CATAWBA NUCLEAR STATION, UNIT 1

AMENDMENT TO FACILITY OPERATING LICENSE

Amendment No. 39  
License No. NPF-35

ATTACHMENT TO LICENSE AMENDMENT NO. 39

FIGURE 3.1-1  
 ROD BANK INSERTION LIMITS VERSUS THERMAL POWER  
 FOUR LOOP OPERATION

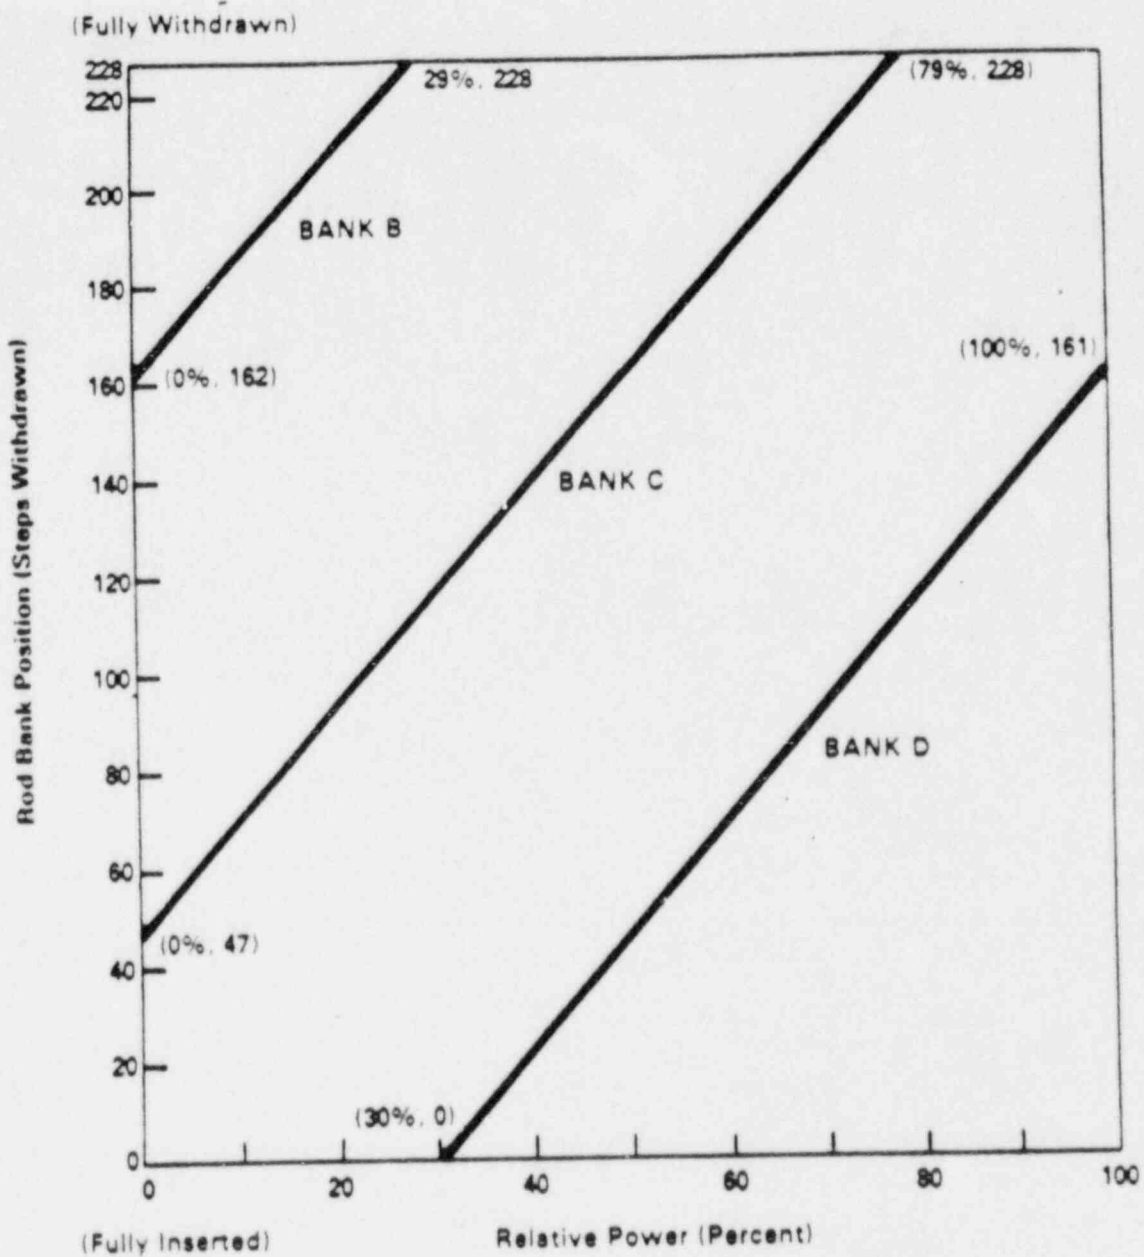
3.1.3.6 The control banks shall be limited in physical insertion as shown in Figure 3.1-1.

- a. Restore the control banks to within the limits within 2 hours,  
or
- b. Reduce THERMAL POWER within 2 hours to less than or equal to that fraction of RATED THERMAL POWER which is allowed by the bank position using the above figure, or
- c. Be in at least HOT STANDBY within 6 hours.

FIGURE 3.2-1  
 AXIAL FLUX DIFFERENCE LIMITS AS A FUNCTION OF RATED THERMAL POWER

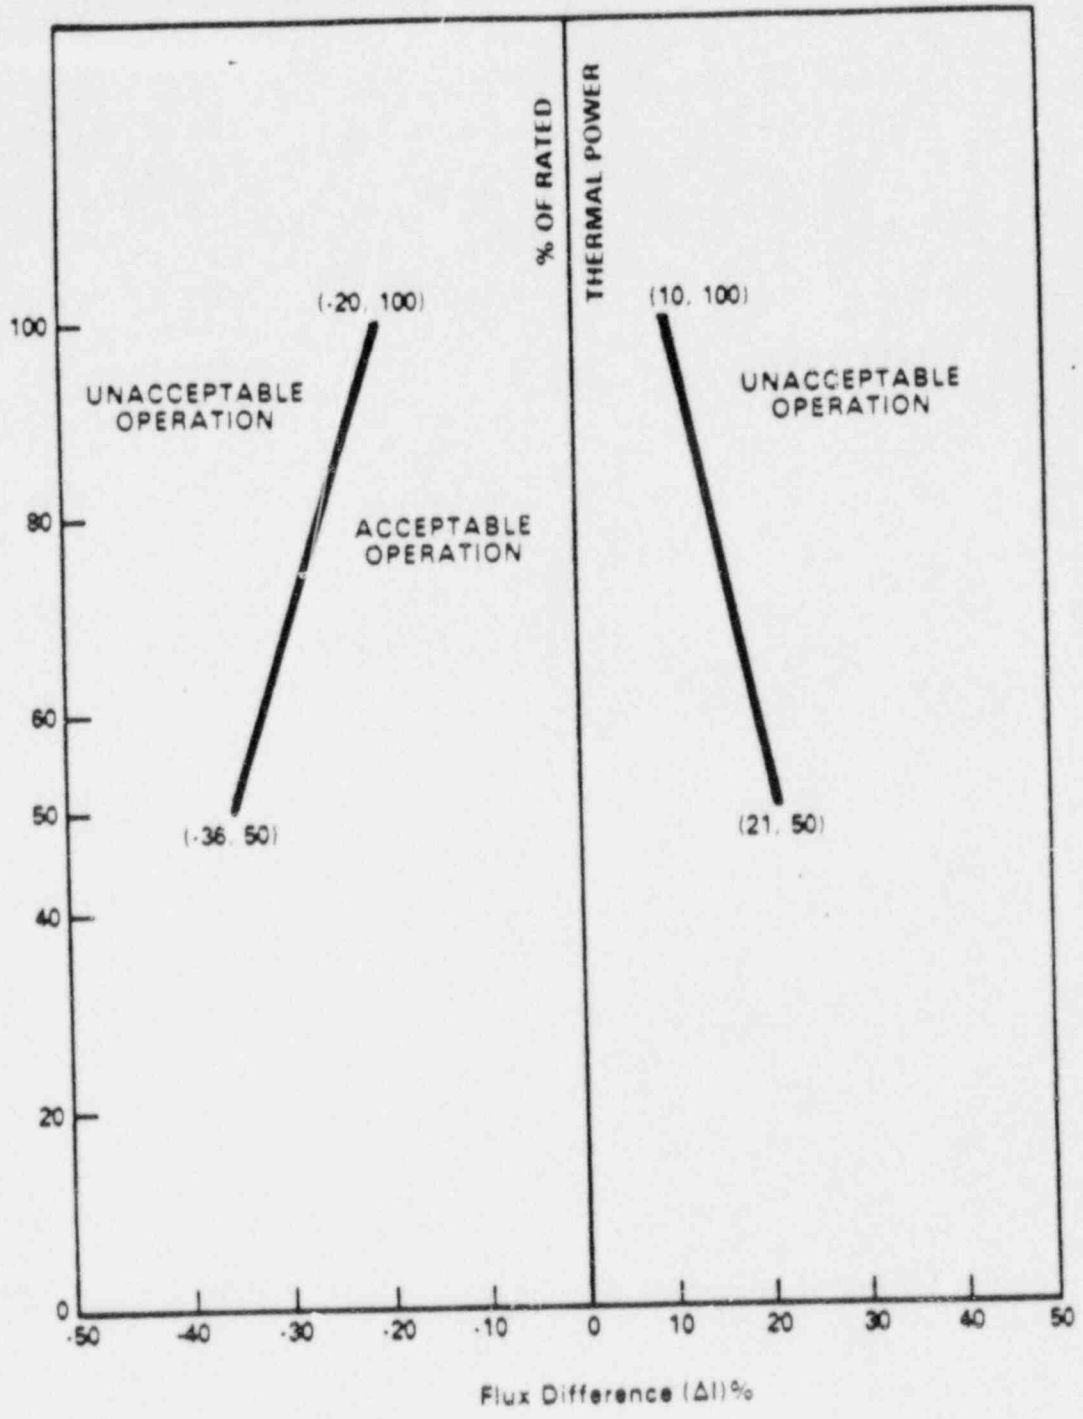
- a. the allowed operational space defined by Figure 3.2-1 for RAOC operation, or
- b. within a  $\pm 3\%$  target band about the target flux difference during baseload operation.

- a. For RAOC operation with the indicated AFD outside of the Figure 3.2-1 limits,
  1. Either restore the indicated AFD to within the Figure 3.2-1 limits within 15 minutes, or

- c. THERMAL POWER shall not be increased above 50% of RATED THERMAL POWER unless the indicated AFD is within the Figure 3.2-1 limits.
